*Re: Water Quality Certification for Application No. 10C-009, Line D and Line D-1 Realignment (CIP# 8157) Project- Petition for Reconsideration*

In the Matter of Water Quality Certification for the City of Murrieta Line D and Line D-1 Infrastructure Protection and Flood Control Project (CIP# 8157)

The City of Murrieta Petition the State Board for Reconsideration of the San Diego Regional Water Quality Control Board's Denial of request for Water Quality Certification (Application No. 10C-009) pursuant to Section 401(A)(1) of the Federal Clean Water Act

Enclosures: Figure 1

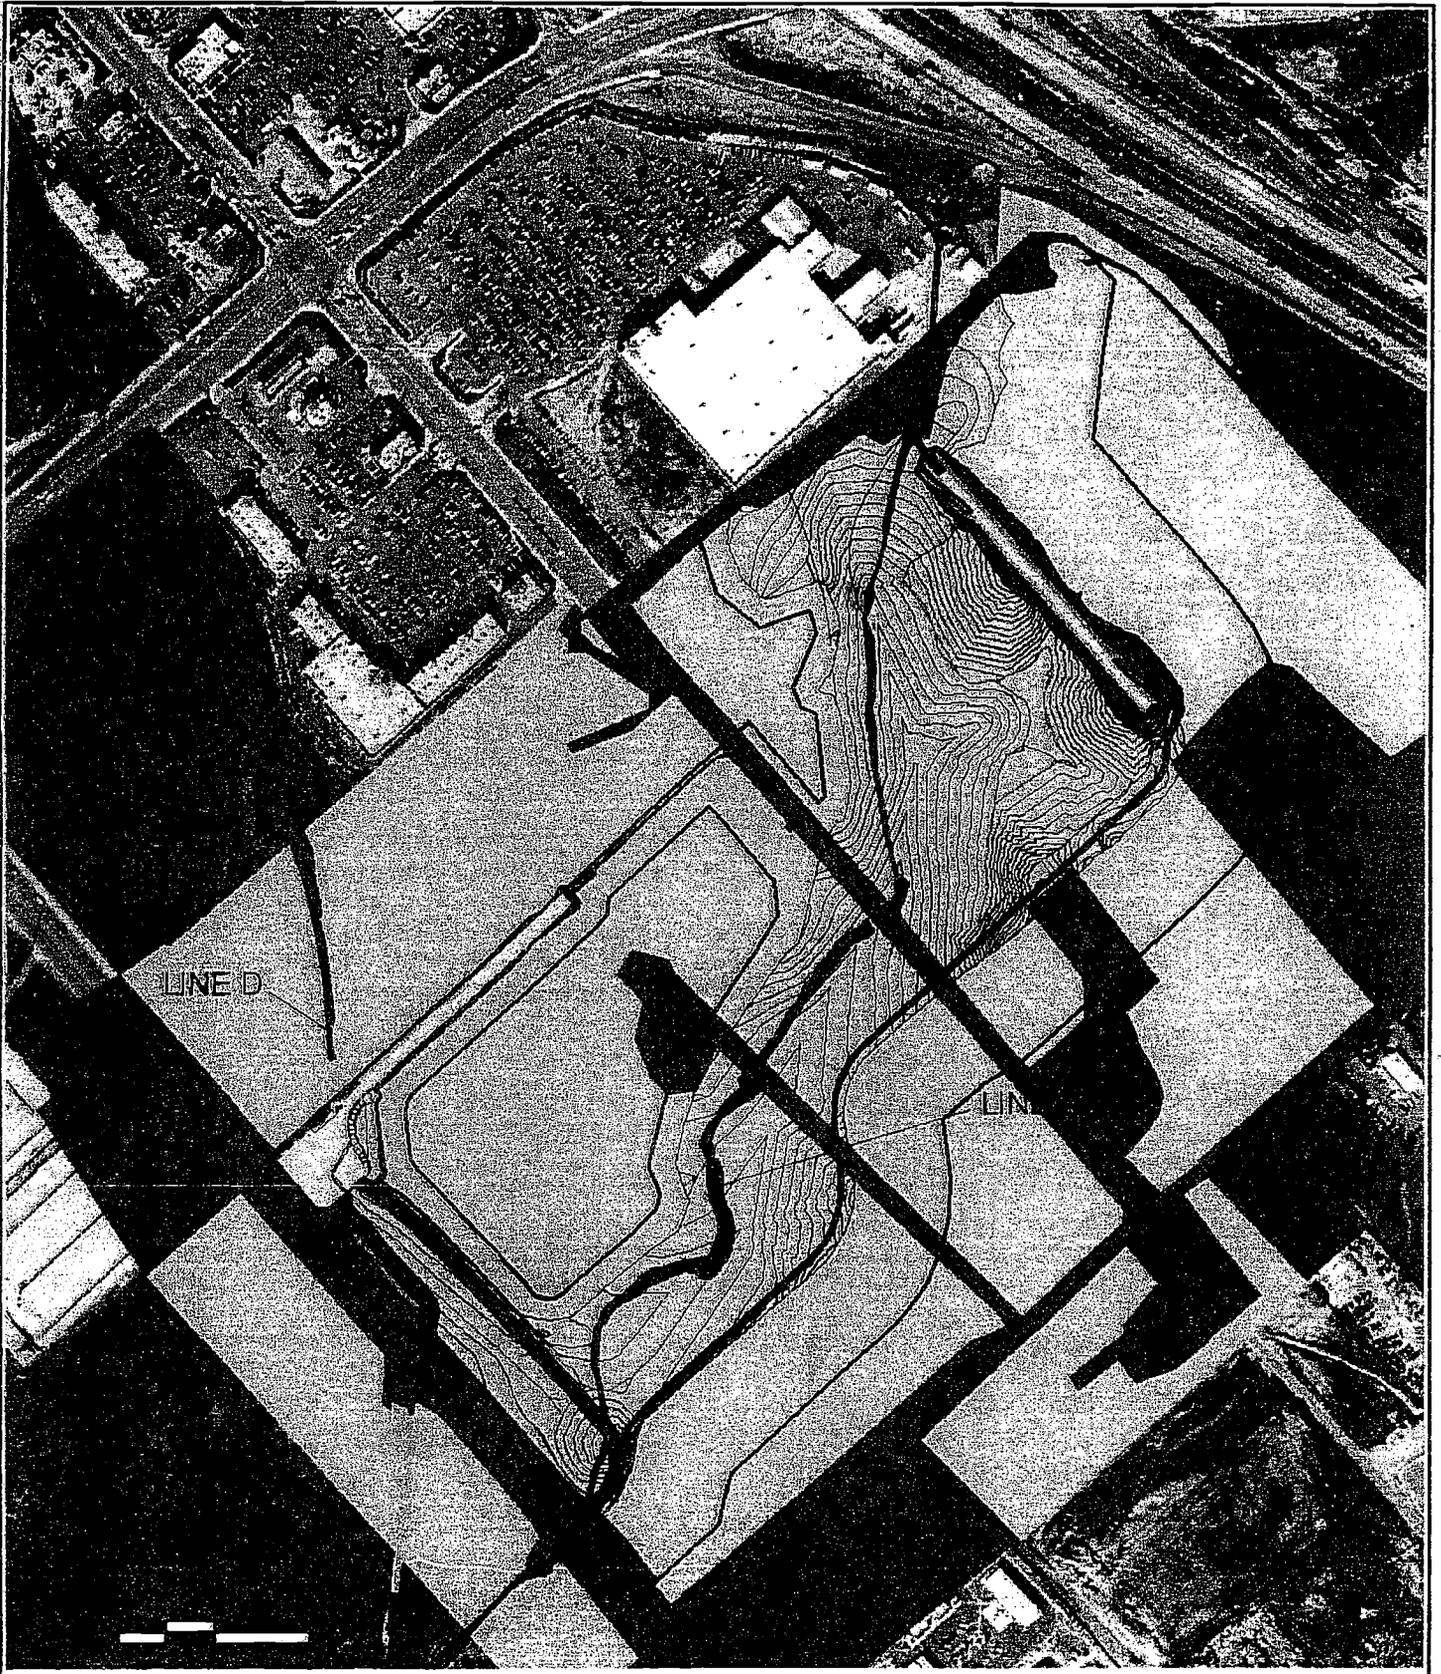
The project proposes to fill in the existing creek channel of Line D-1 and route the storm water flows from Line D and D-1 into two open channels which connect to underground pipes that discharge back into Line D and D-1 southwest of Jefferson Avenue (See attached Figure).
